PIRU BASIN GROUNDWATER SUSTAINABILITY PLAN Map of Groundwater Quality Trends, Nitrate (NO3)

**Fillmore and Piru Basins Groundwater
Sustainability Agency Stakeholder
Communications and Engagement Plan
October 27, 2021**

Figure 2.2-33

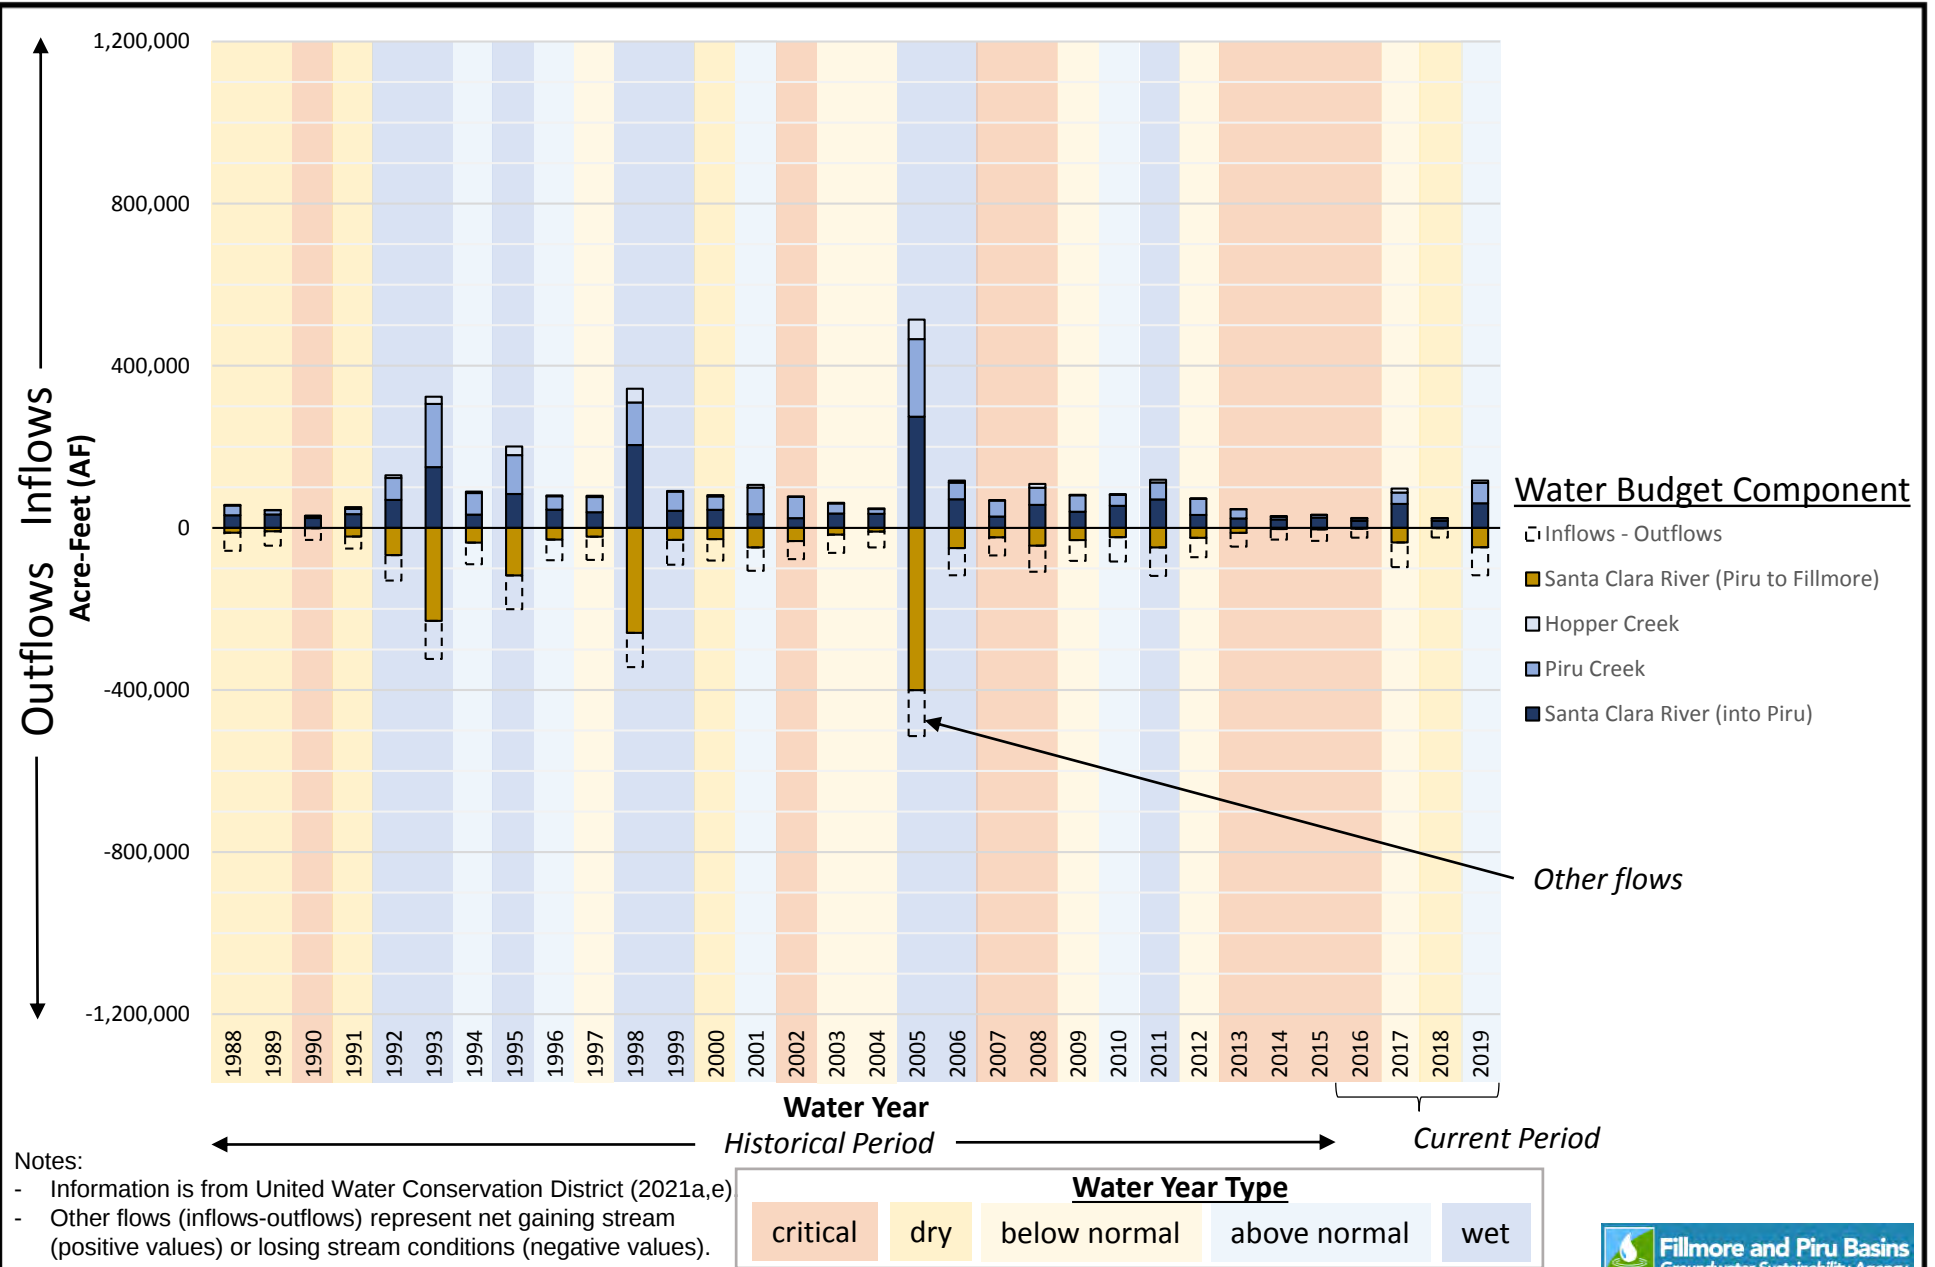
Fillmore	9	9-9	Ventura County Public Works Agency	10/8/2021	NS	NS	NS	Editorial - figure numbers	The water budget graphic is incorrectly identified as Figure 2.2-30 in the text. It should be identified as Figure 2.2-33.	The text has been adjusted.
Fillmore	9	9-10	Ventura County Public Works Agency	10/8/2021	2.2.2.7	NS	NS	Surface water diversions	It would be informative to list surface water diversions for the tributaries of the Santa Clara River within the Subbasin and estimated annual quantity of diverted water for each (Section 2.2.2.7). Is this represented as the "Unaccounted Flows" value in Table 2.2-11?	See updated Sections 2.2.2.7 and 2.2.3.1.2
Fillmore	9	9-11	Ventura County Public Works Agency	10/8/2021	2.2.3.3.2	2-72	3-6	Pumping levels	On page 2-72, lines 3-6, the apparent reduction in average pumping demand during the current drought is inferred, as metered pumping data are not available. The lower recent pumping could be an artifact of the water budget calculations and not supported by evidence (pumping data and/or groundwater levels).	This is based on estimates from production data reported to United (i.e., Fish Hatchery reduced pumping significantly).
